Re: Sienna Section 27

Removal of Sidewalk along Reserve A Sienna Municipal Utility District No. 6 LJA Job No. 1416-1527P (6.1)

TRAFFIC CONTROL AND STREET LIGHT LAYOUT

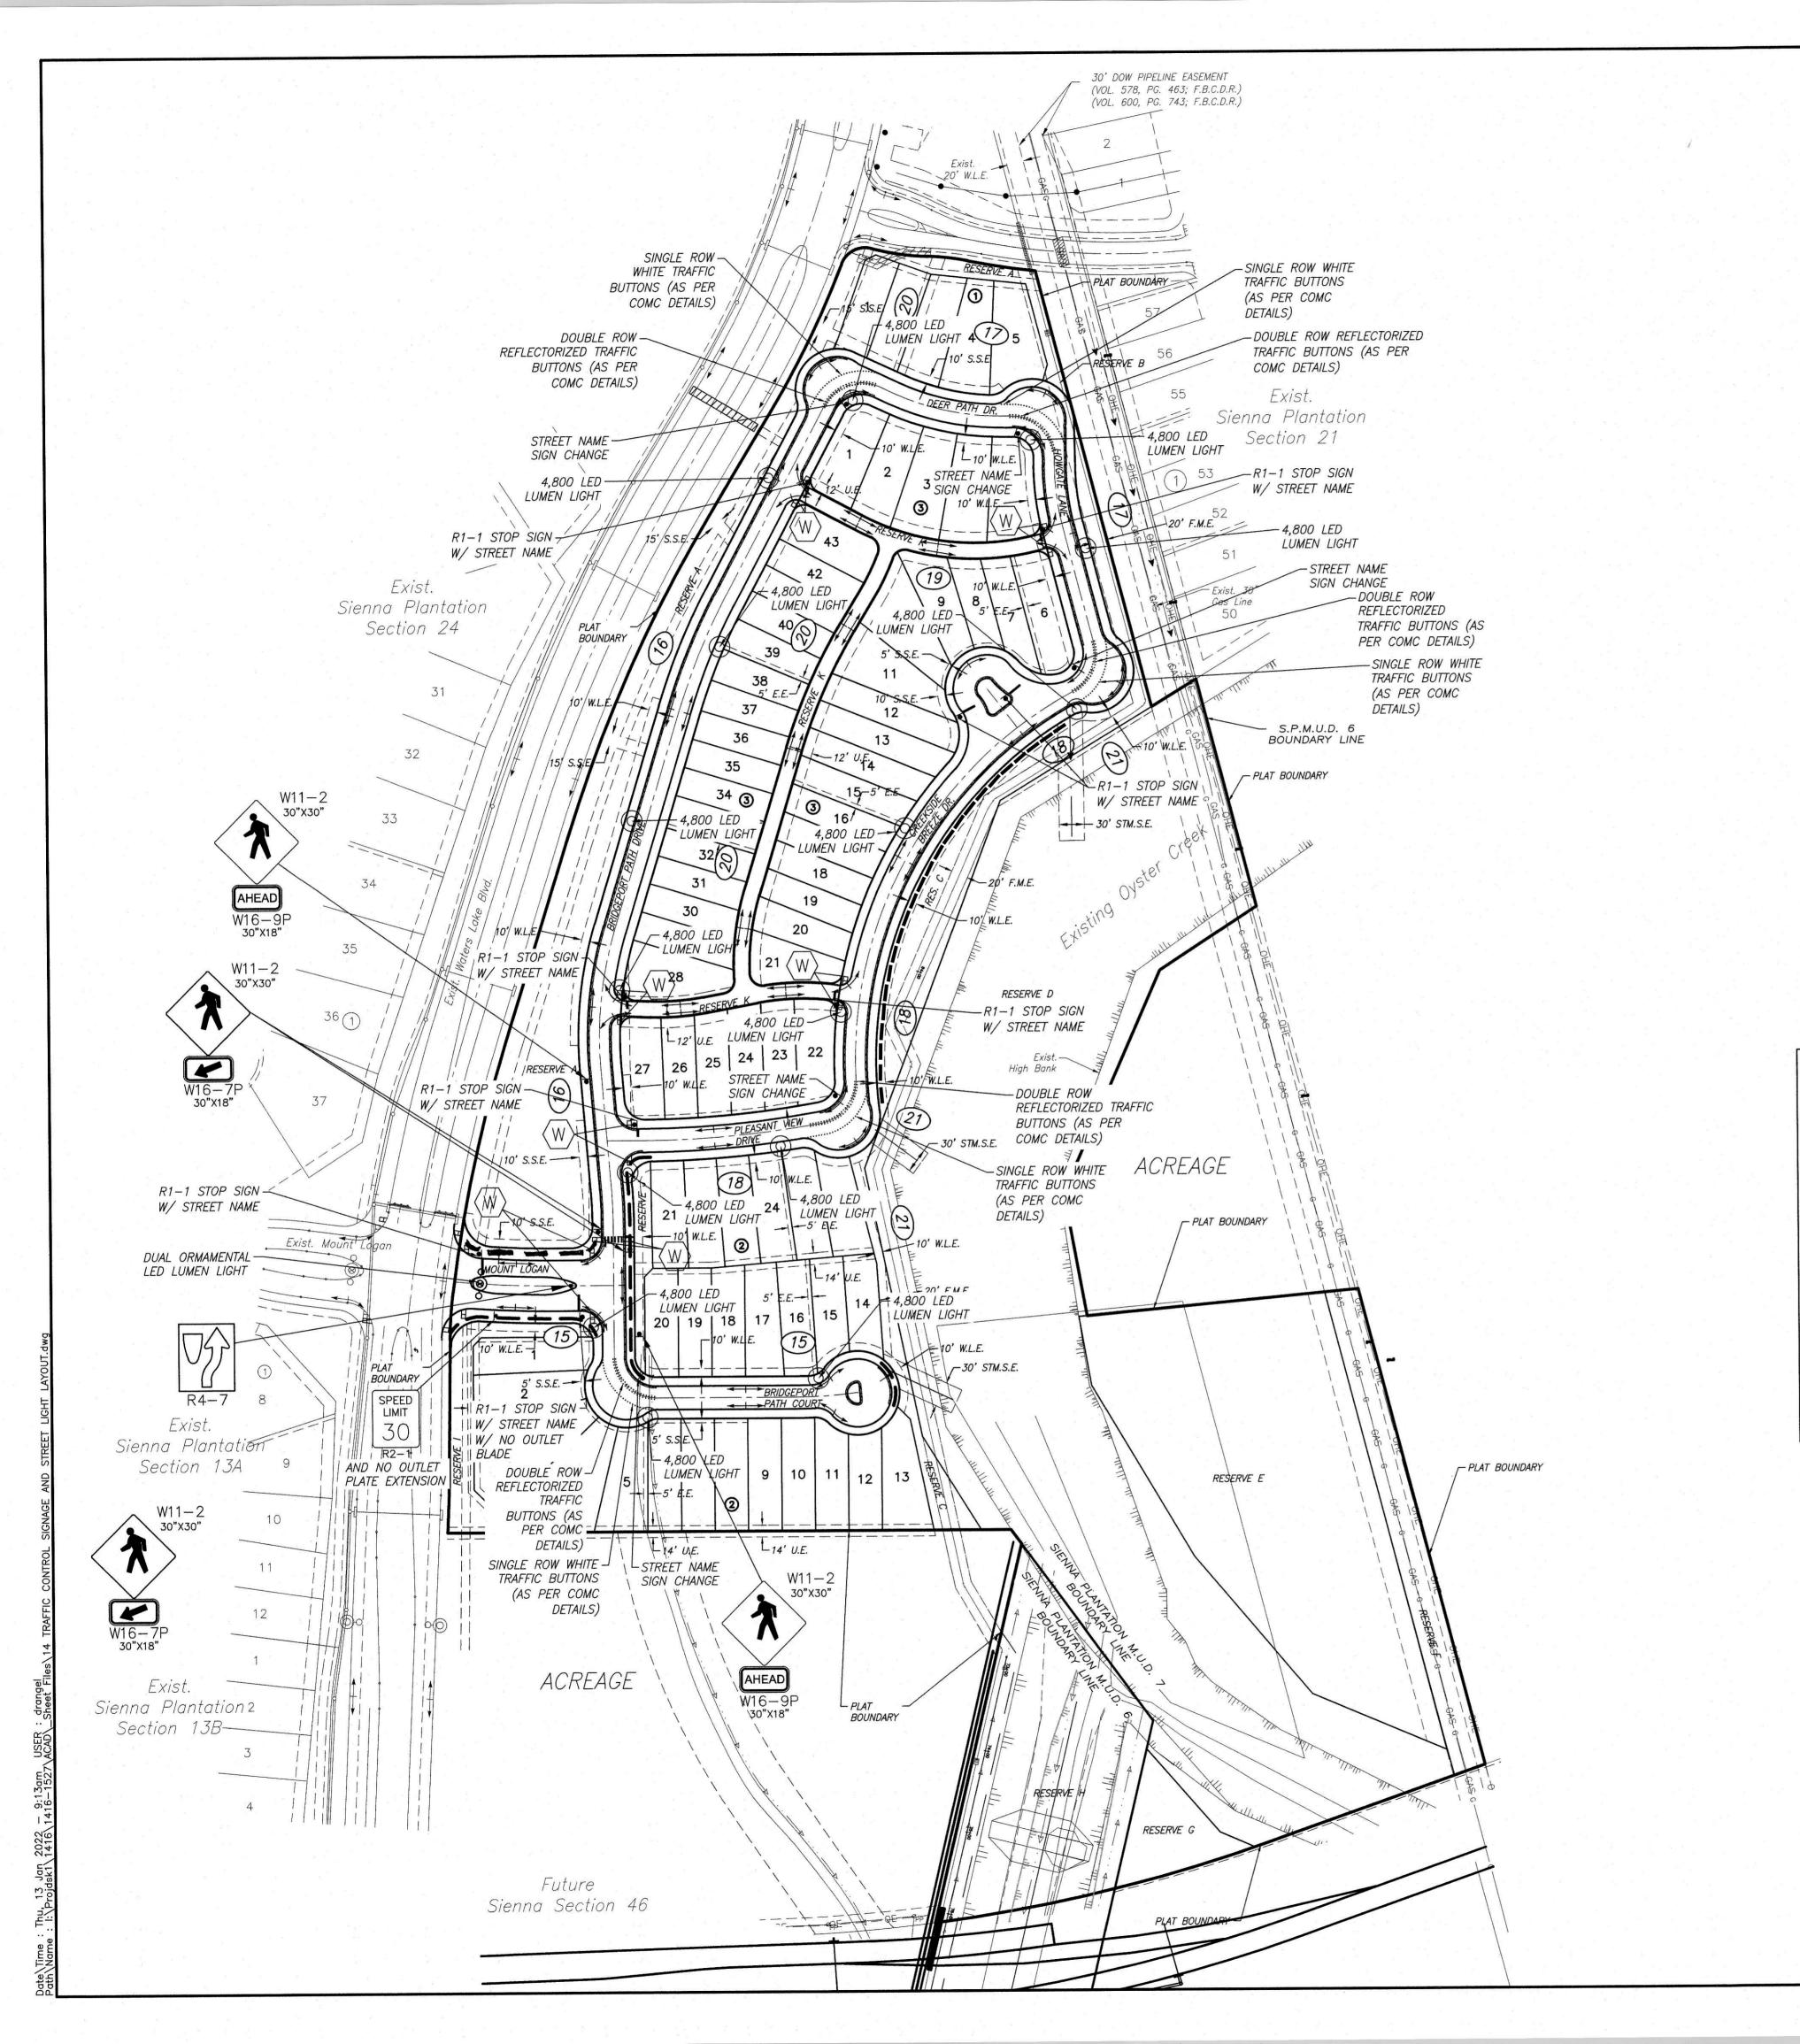
LJA is requesting permission to remove the required sidewalk along Reserve A within the platted subdivision of Sienna Section 27. As per criteria, sidewalks are required to be constructed within reserves. As shown below, a sidewalk is already located within the right of way at Waters Lake Boulevard as shown below in yellow.

Since there is already sufficient pedestrian access for this section and a sidewalk parallel to the reserve, we respectfully request that we be allowed to remove the required sidewalk from the traffic control plan for this section as shown on the attached revised layout. This layout has already been approved by the City of Missouri City as well.

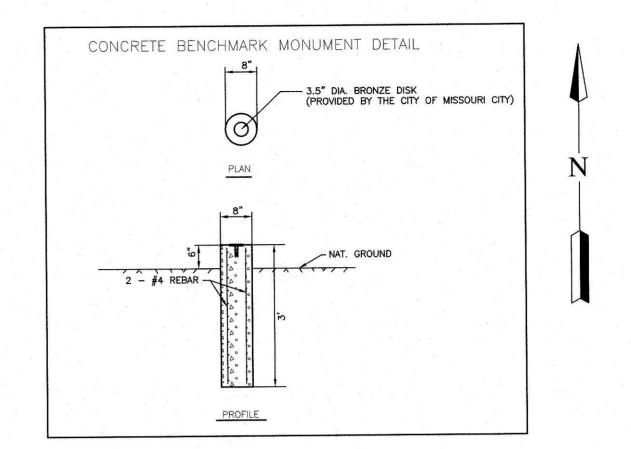
DATE REVISION
1/13/32 Revised sidewalks
